TB-012

Models: EC/ECI/HCI

Re: Lower Clevis Upgrade

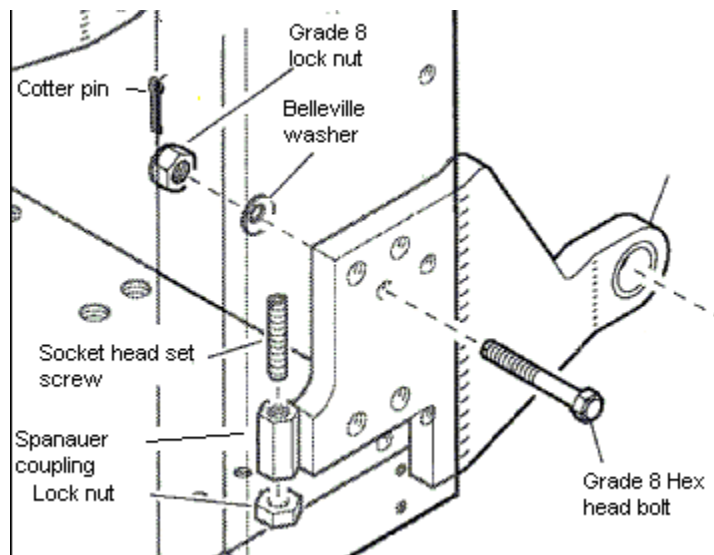
There is an upgrade available for the lower mainframe clevis assemblies. This upgrade is being offered to assist with prevention of damage to the mounting bolts. The bolts can be damaged if there is rotational movement of the clevis. The upgrade consists of the addition of a jacking bolt and Belleville washers in the configuration shown below in order to reduce the risk of clevis movement. This upgrade is being offered through the Tesco Service Department as part of Tesco's Exchange Program. Upon receipt of a purchase order, a kit including new mounting hardware and mount plates will be supplied. When the original plates are returned a credit note will be issued. Please contact Jeff Salkeld 403-233-0757 for clarification or to arrange to purchase a kit.
